Auf Dauer technisch dichte Brenngasleitung

Addendum to Operating Instructions

Permanently technically tight fuel gas line

5. Automatische Zündung

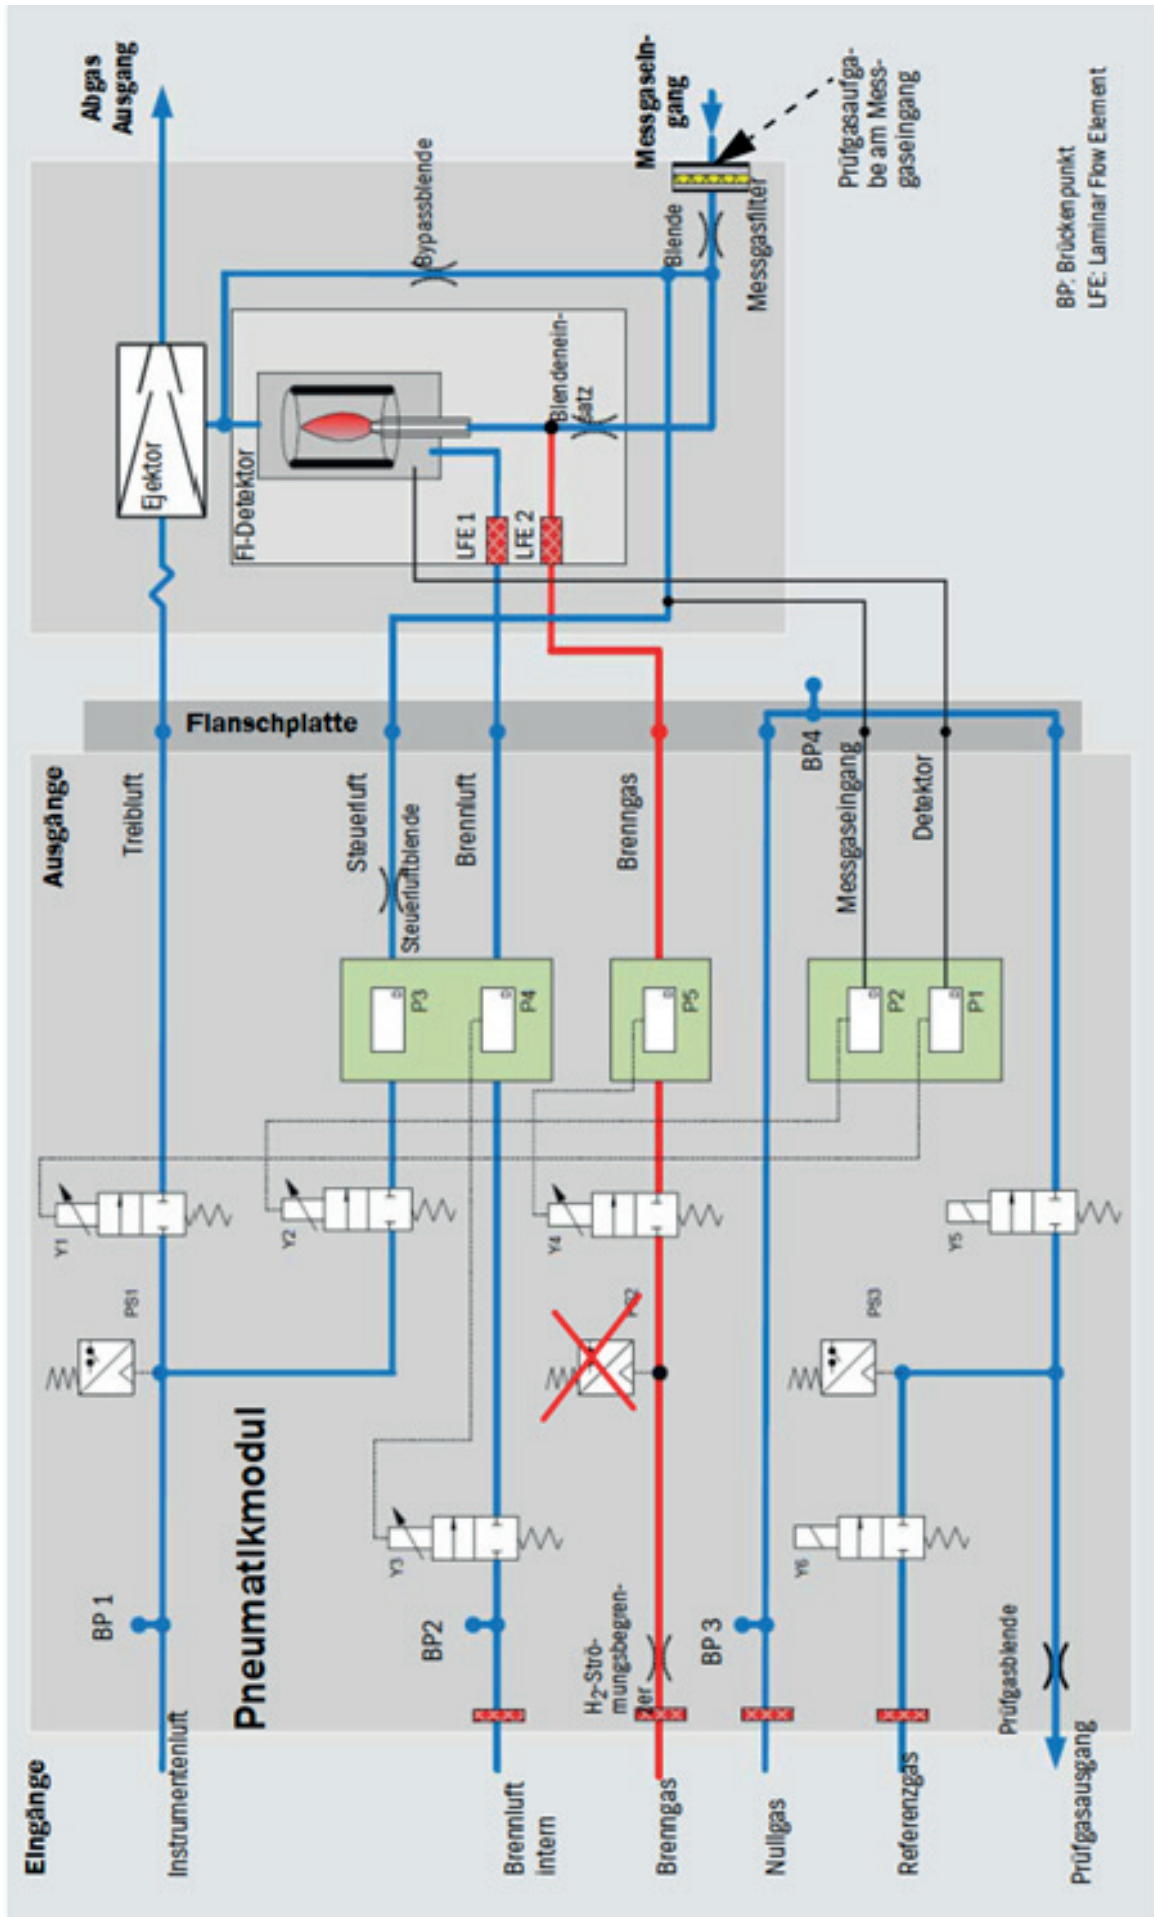
Durch die Deaktivierung des Druckschalters für das Brenngas findet nach einem Druckverlust in der Versorgungsleitung (bspw. Flaschenwechsel) keine automatische Zündung statt, so dass der Zündvorgang manuell gestartet werden muss, z.B. über SOPAS ET oder an der BCU.

6.1 Gasflussschema (FIDOR ohne Katalysator)

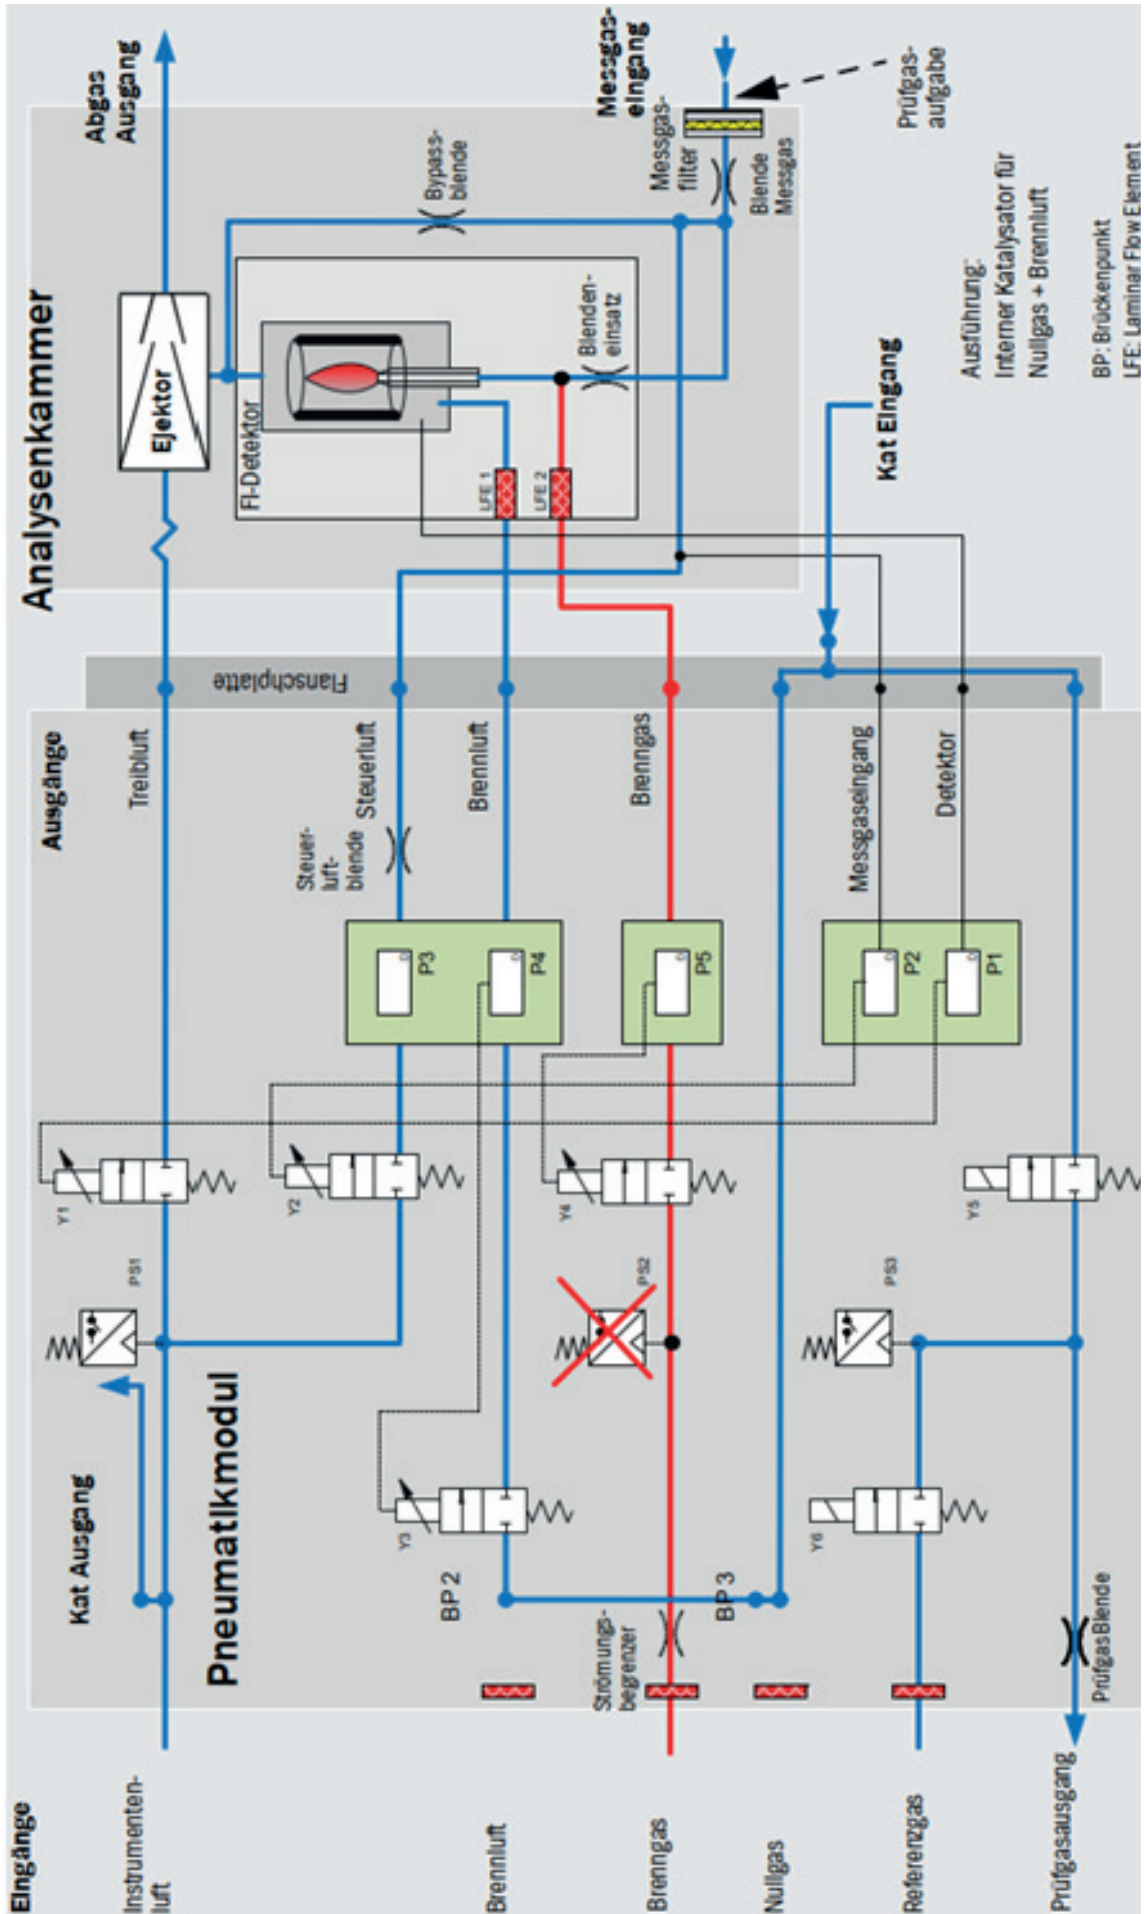
Im Folgenden sind die Abweichungen zur in der Betriebsanleitung abgebildeten Gasflussschemata kenntlich gemacht (Druckschalter PS2 entfällt).

5. Automatic ignition

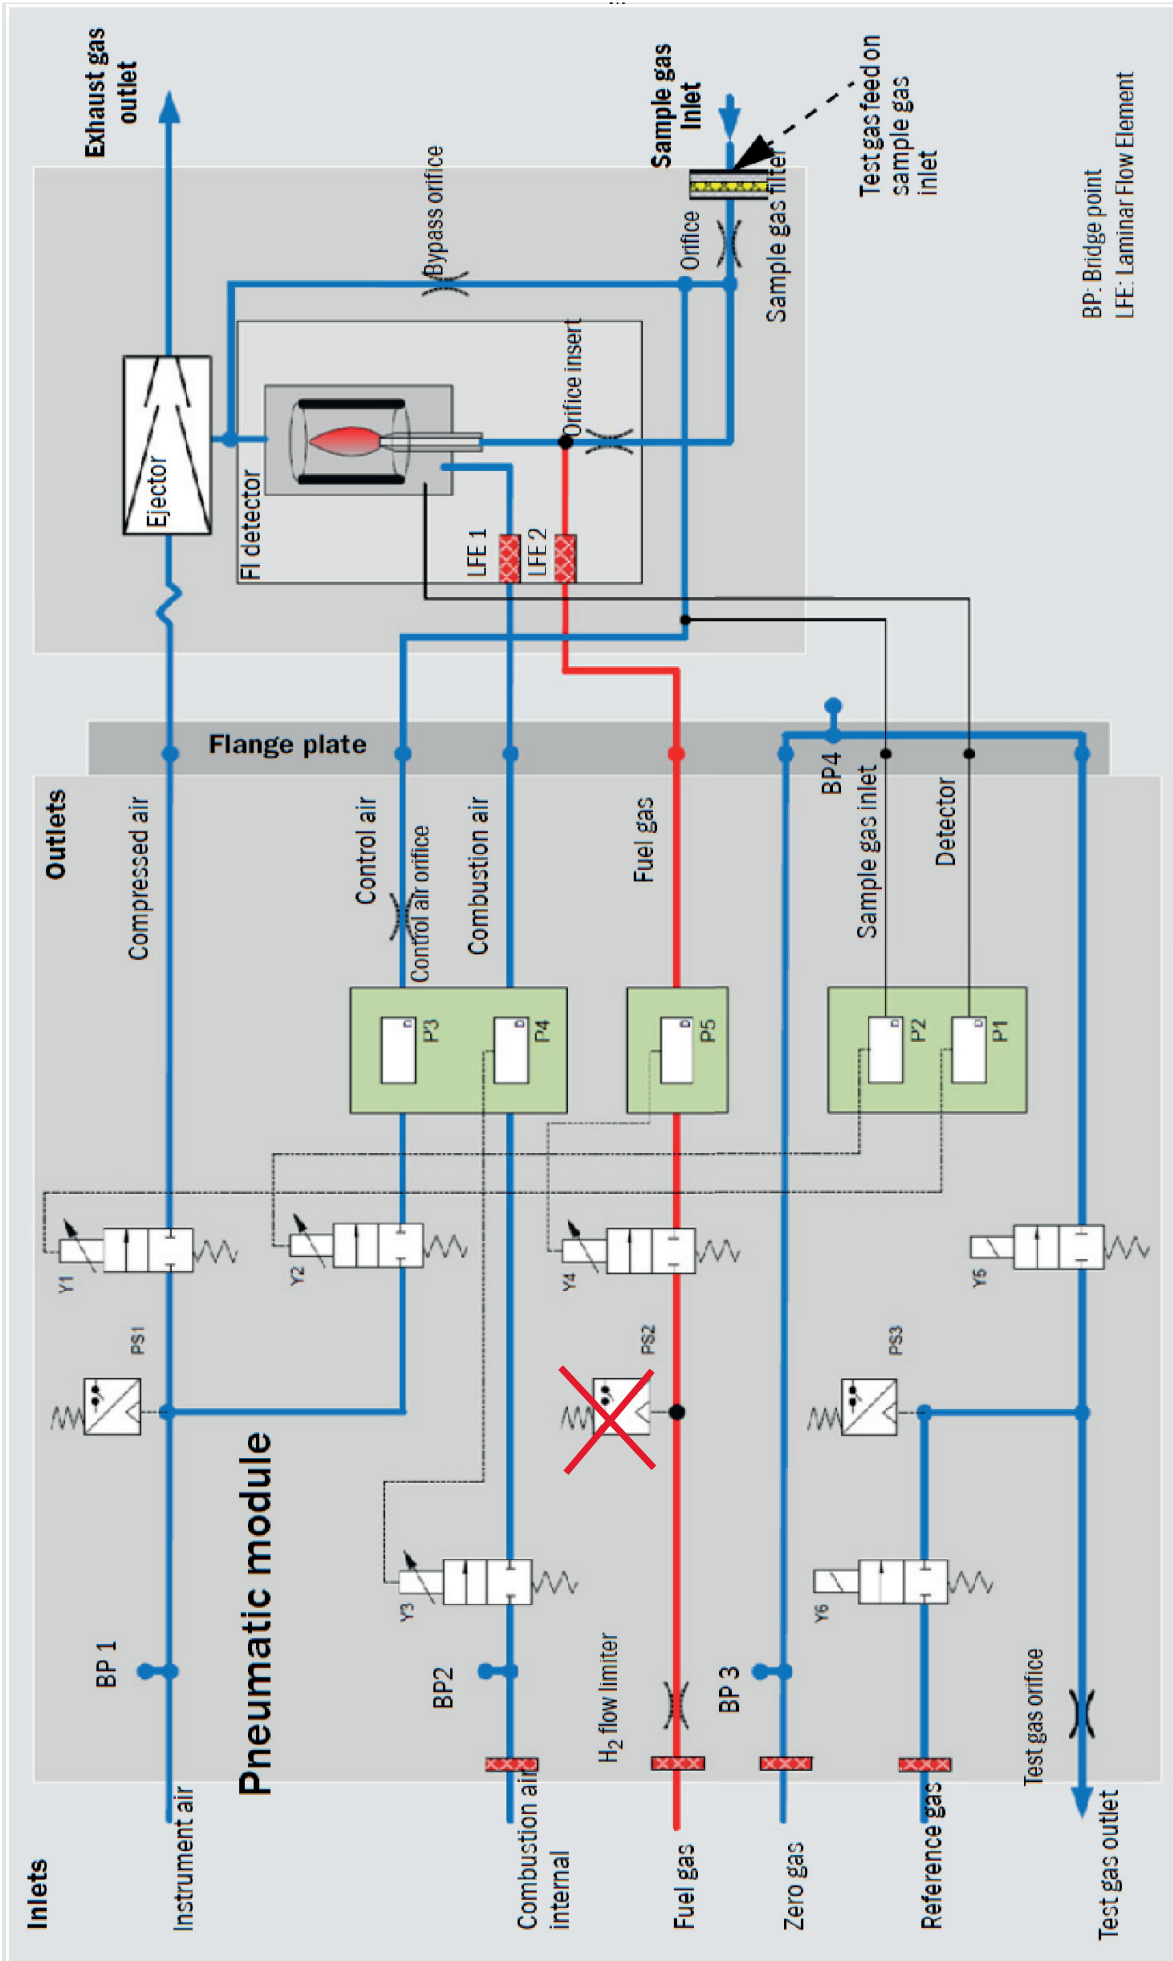
As a result of deactivating the pressure switch for the fuel gas, there is no automatic ignition after a pressure loss in the supply line (e.g. cylinder change), so that the ignition process must be started manually, e.g. via SOPAS ET or on the BCU.
